Contract #: 04-0120F4Cty: SF/ALA Rte: 80 PM: 13.2/13.9File #: 69.25B**QUALITY ASSURANCE -- NON-CONFORMANCE REPORT****Location:** Changxing Island, Shanghai, P.R. China**Report No:** NCR-000835**Prime Contractor:** American Bridge/Fluor Enterprises, a JV**Date:** 07-Sep-2010**Submitting Contractor:** Zhenhua Port Machinery Company, Ltd (ZPMC), Changxing Island**NCR #:** ZPMC-0797**Type of problem:**

Reference Description: ZPMC performed repair on Suspender Bracket 74E at Lift 9E without having an approved CWR

Subject: NCR No. ZPMC-0797

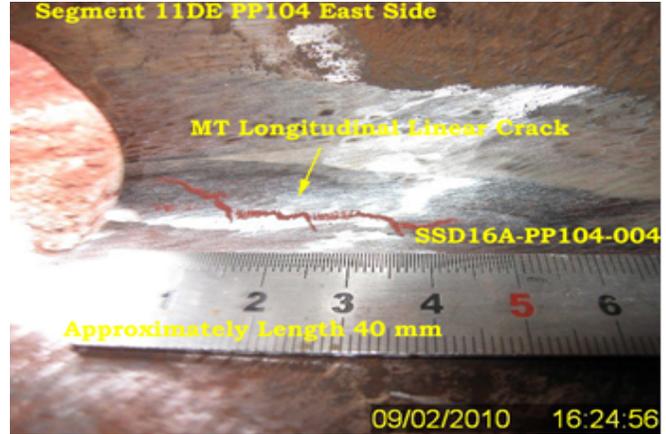
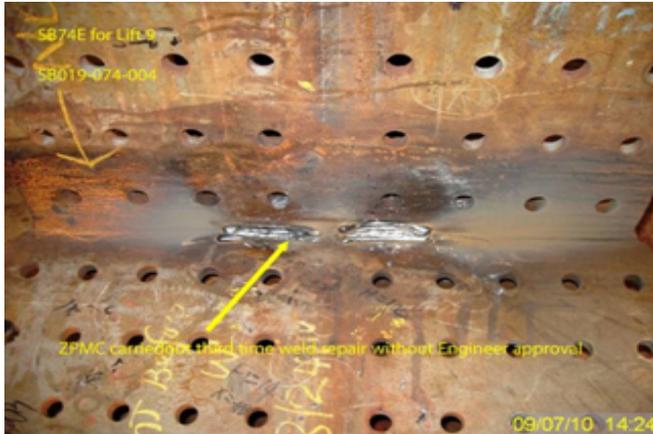
- ZPMC personnel performing weld repair of one (1) transverse crack measuring approximately 10 mm without the prior approval of the Engineer, an approved Critical Weld Repair (CWR), or following the "pre-approved CWR" procedure that was agreed jointly.

- This weld is rejected for the 3rd time by Ultrasonic Testing.
- The transverse crack found in the excavation with Magnetic Particle Testing verification by ZPMC personnel after carbon arc gouging.

- The weld is identified as SB019-074-004 for OBG Lift 9E.
- Y-location of the transverse crack without CWR is at 310mm from the left end of X53B.
- Subsequent to the completion of weld repair, ZPMC sought for a CWR approval from CT for a longitudinal crack repair at a different location on the same weld joint.

- As of September 8, 2010 at 11:00, no CWR or Engineer's approval has been requested from ZPMC for this transverse crack defect.
- This member is located inside the OBG Fabrication shop Bay 19.

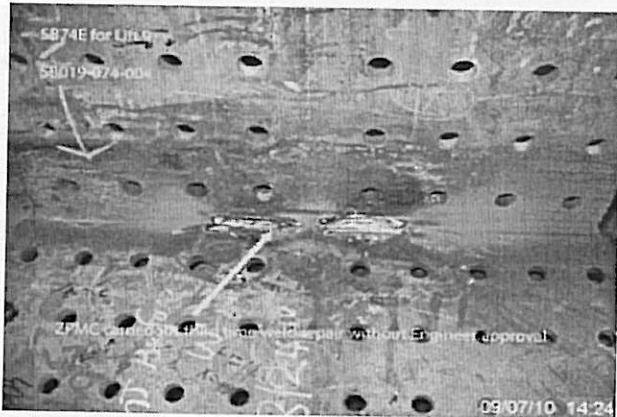
- ZPMC personnel performing weld repair of one (1) transverse crack measuring approximately 10 mm without the prior approval of the Engineer, an approved Critical Weld Repair (CWR), or following the "pre-approved CWR" procedure that was agreed jointly.

- This weld is rejected for the 3rd time by Ultrasonic Testing.
- The transverse crack found in the excavation with Magnetic Particle Testing verification by ZPMC personnel after carbon arc gouging.

- The weld is identified as SB019-074-004 for OBG Lift 9E.
- Y-location of the transverse crack without CWR is at 310mm from the left end of X53B.
- Subsequent to the completion of weld repair, ZPMC sought for a CWR approval from CT for a longitudinal crack repair at a different location on the same weld joint.

- As of September 8, 2010 at 11:00, no CWR or Engineer's approval has been requested from ZPMC for this transverse crack defect.
- This member is located inside the OBG Fabrication shop Bay 19.
